Date: April 28, 2011
To: Water Right File 01-7010B
From: medl
Re: Dam Safety File D36-XX02

The following pages were copied from the inactive Dam Safety file for the Bypass Limited hydro project.

RE: Northside Main Canal, Proposed Hydro Project

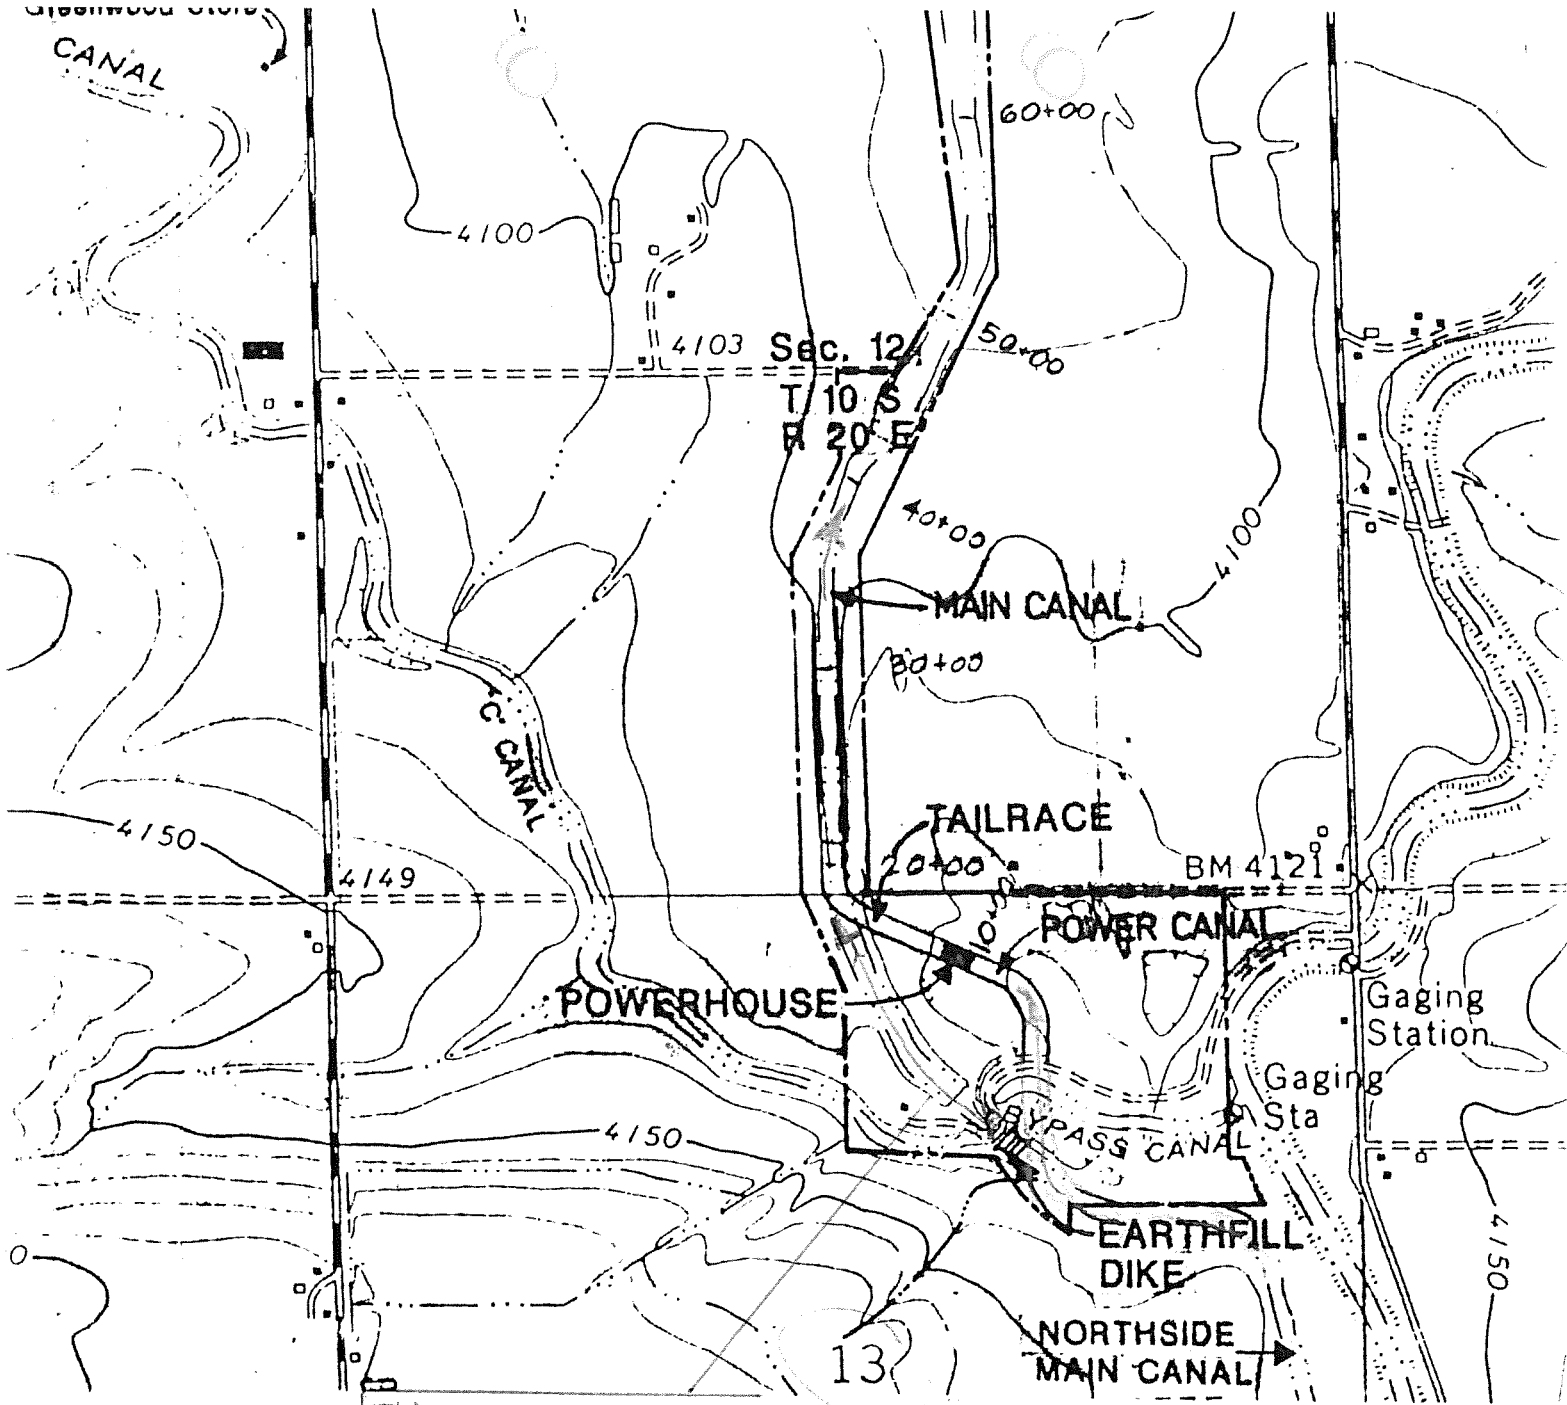
I have examined the drawings for reconstructing a segment of the Northside Main Canal, that includes installation of an earthfill dike to redirect the flow to the proposed hydro plant. The dike appears to be a plug (to block flow in the canal segment to be abandoned) and is not considered a dam that is within the jurisdiction of this Department.
